TECHNICAL BULLETIN

206-23-212

SUBJECT: SEGMENTED TAIL ROTOR DRIVESHAFTS,
RETROFIT OF.

HELICOPTERS AFFECTED: Serial numbers 4 through 1251.

Figure 1 – Tail Rotor Driveshaft Installation

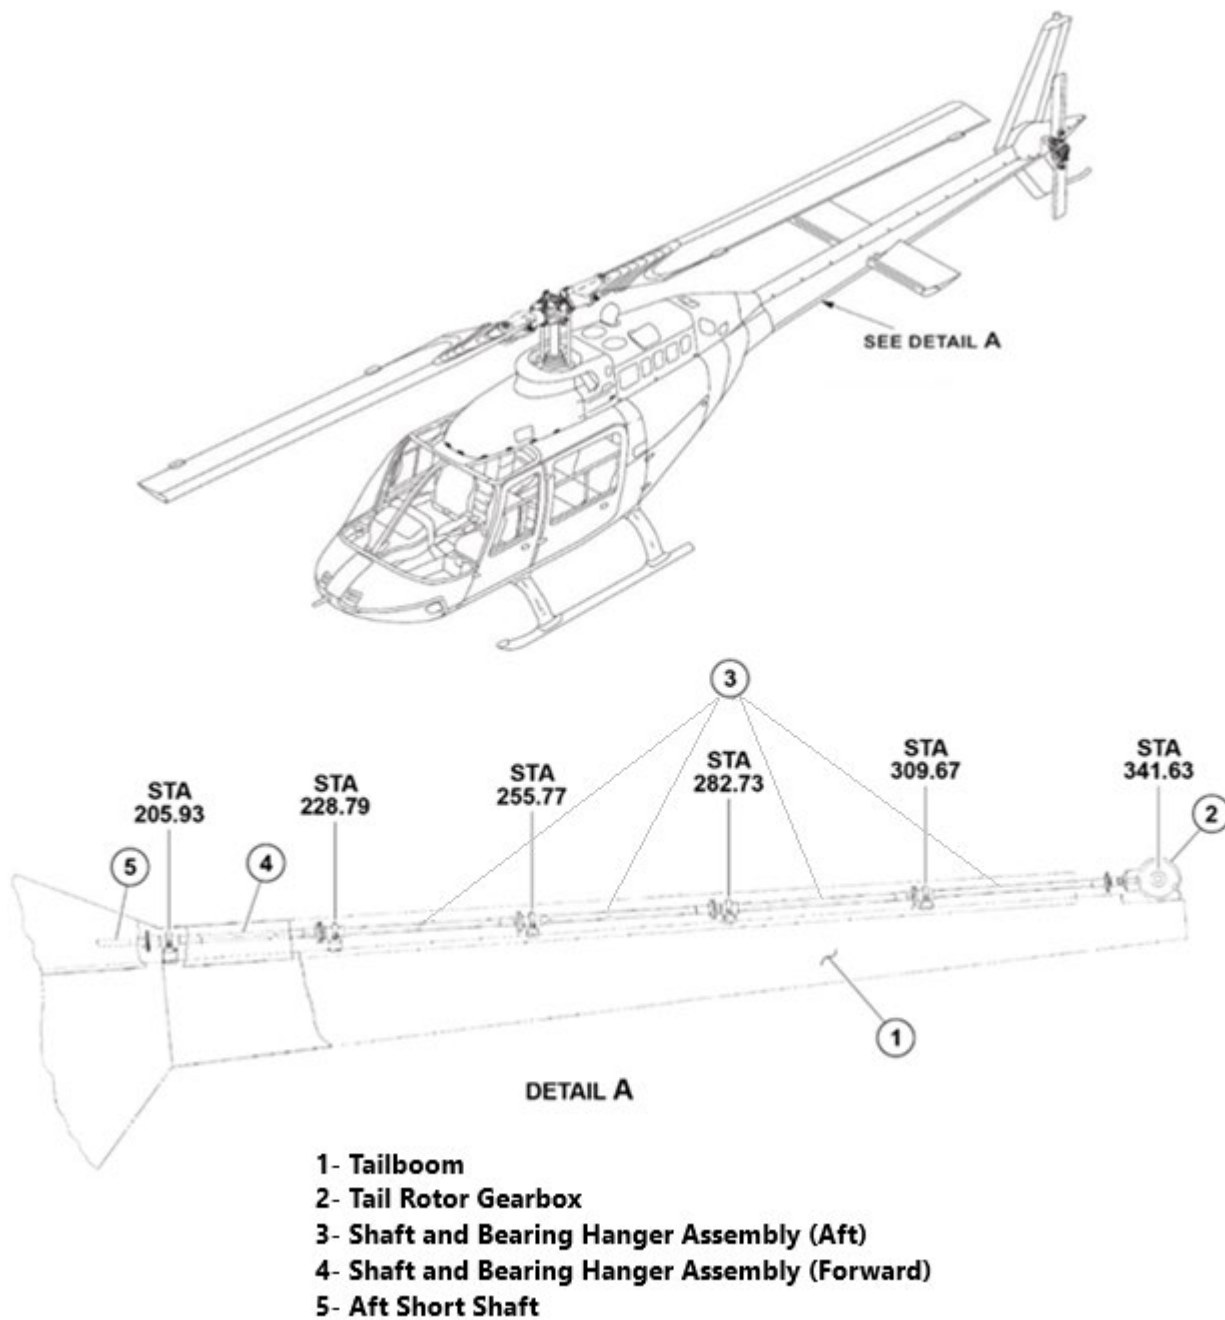
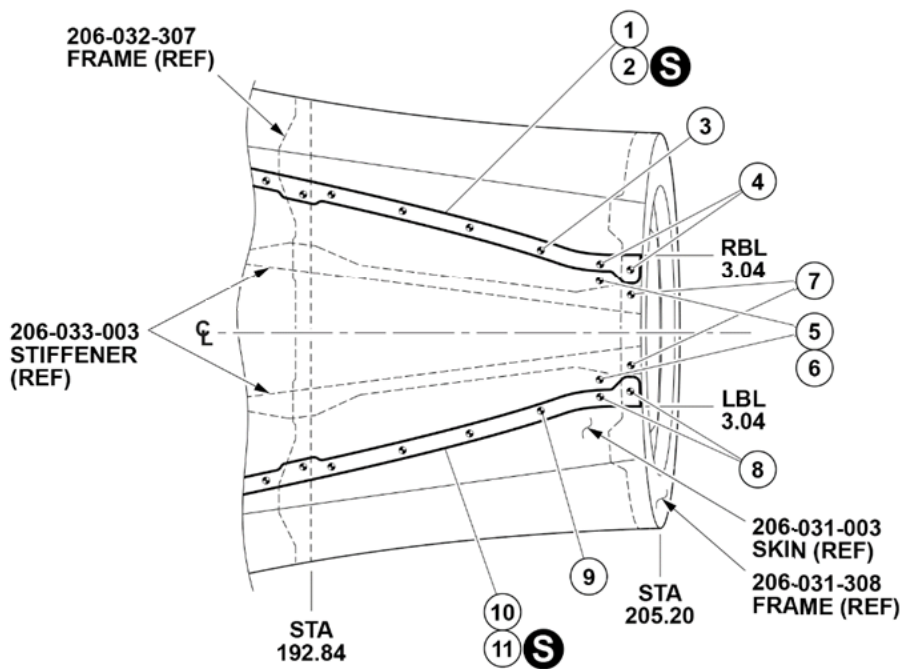
- o. Remove the tailboom assembly (1, Figure 1) (Chapter 53). Discard the attachment hardware.
 - p. For S/N 4 through 637 only, verify the helicopter records to confirm if the oil cooler blower shaft 206-040-320-007 has been modified and installed as per Part V of ASB 206-76-12. If not, remove the oil cooler blower assembly and install the shaft assembly 206-040-320-011 (or approved replacement as per Appendix B, Table B-1) into the oil cooler blower assembly (BHT-206B3-CR&O-4).

- a. Prepare the replacement tailboom assembly (1, Figure 1) as follows:
 - (1) Install the pivot bellcrank assembly and the long control tube assembly (Chapter 67).
 - (2) Install the electrical harness previously removed from removed tailboom (Chapter 96, BHT-ELEC-SPM).

- b. Install the replacement tailboom assembly (1, Figure 1) (Chapter 53) on the fuselage assembly, using new attachment hardware. Pay particular attention to the upper left bolt location, in relation to the tailboom assembly part number is being installed (BHT-206A/B-SERIES-IPB, Chapter 53).
- c. Install the spar and the two horizontal stabilizer assemblies (Chapter 53).
- d. Install the replacement tail rotor gearbox assembly (2) (Chapter 65).
- e. Install the pitch change mechanism onto the gearbox assembly (2) (Chapter 67).
- f. Service the gearbox with the proper oil quantity (Chapter 12).

- g. Install the aft short shaft assembly (5, Figure 1) and connect to the oil cooler and blower assembly (Chapter 65).
- h. Install the forward shaft and bearing hanger assembly (4) and the four aft shaft and bearing hanger assembly (3) on the tailboom (1) (Chapter 65).
- i. Service all tail rotor driveshaft bearings using Mobil 28 grease (C-001) (Chapter 12).
- j. Install the tail rotor hub and blade assembly. (Chapter 64). Service Hub & Blade assembly with applicable grease (C-001 or C-172) (Chapter 12, TB 206-13-206).

Figure 2 – Fairing Retainer Installation and Modification

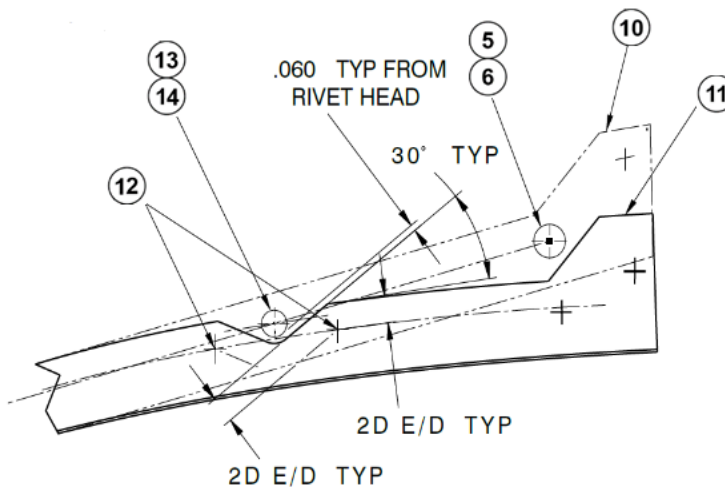
5. Replace the two aft fuselage oil cooler fairing retainers (1, and 10, Figure 2) as follows:
 - a. Record the type, the size and the location of the rivets securing existing left and right oil cooler fairing retainers (1, and 10) on the aft end of fuselage.

- b. Drill out all the rivets and remove the retainers (1, and 10).
 - c. Drill out the 3/32 rivets and remove the nutplates, inspect and replace as required.

Make sure equal distance exists between centerline of aft fuselage and each vertical flange of new retainers (2, and 11).

- d. Temporarily fit and secure in place the new retainers (2, and 11) and the new aft fairing assembly.
 - (1) Latch the fasteners of the fairing mating with the aft engine firewall.
 - (2) Clamp each vertical flange of the retainers (2, and 11) to the wall making the aft aperture of the fairing.
- e. Mark the center position of the retaining Dzus fastener holes common with the vertical flange of each retainer (2, and 11).

The different shape of the new retainers (2, and 11) will leave four existing rivet holes (5 and 7) in aft fuselage top skin unused. Those must be plugged.

- f. Except for one rivet hole (13) in lower flange of each new retainers (2, and 11), all other rivets that will be drilled must have a 2D minimum edge distance (ED).

- (a) Transfer all rivet holes from aft fuselage top skin to the lower flange of each retainer (2, and 11), including the hole that will have low ED.
 - (b) Drill two additional rivet holes (12) through retainers (2, and 11) and the aft fuselage skin, one on each side where trimming will occur at the rivet low ED (13). Maintain 2D edge distance and 4D pitch with existing rivet holes to secure new retainers (2, 11).

- g. Remove the aft fairing and the two retainers (2 and 11).
 - (1) Trim the lower flange of the retainer where the rivet low ED (13) exists to maintain proper clearance with the aft fuselage top skin plugging rivet.

- (2) Deburr all holes in retainers (2, and 11).
- h. Drill 0.467/0.474-inch (11.86/12.03 mm) diameter holes required in the vertical flange of the retainers (2 and 11).

- (2) Deburr all holes. Install the Dzus fasteners receptacles using rivets MS20426AD3.
- i. Coat the lower faying surfaces of the new retainers (2, and 11) with sealant (C-251) and install in place on the aft fuselage with the rivets (3, 4, 8 and 9).
 - j. After installation of the new retainers (2, and 11), install anti-chaffing tape (C-454) on vertical flange of both retainers (2, and 11).

The installation of washers (6 and 14) and rivets (5 and 13) shall not interfere with the aft fuselage hidden structure nor with the lower flange of the new retainers (2, 11). It is acceptable to trim the lower flange of the retainers (2, and 11) to eliminate any interference from the washers/rivet's installation (14, and 13).

- k. Enlarge the diameter of the two unused forward rivet holes in aft fuselage top skin using a #27 drill bit for installation of 1/8 oversize diameter blind rivets (13) and washers (14).

- (1) Deburr holes.
 - (2) Coat the shank of the rivets (13) and the faying surface of the washers (14) with sealant (C-251) and install to plug the four unused rivet holes on aft fuselage top skin.

- l. Enlarge the diameter of the two unused aft rivet holes in aft fuselage top skin using a # 16 drill bit for installation of 5/32 oversize blind rivets (5) and washers (6).

- (1) Deburr holes.
 - (2) Coat the shank of the rivets (5) and the faying surface of the washers (6) with sealant (C-251) and install to plug the four unused rivet holes on aft fuselage top skin.
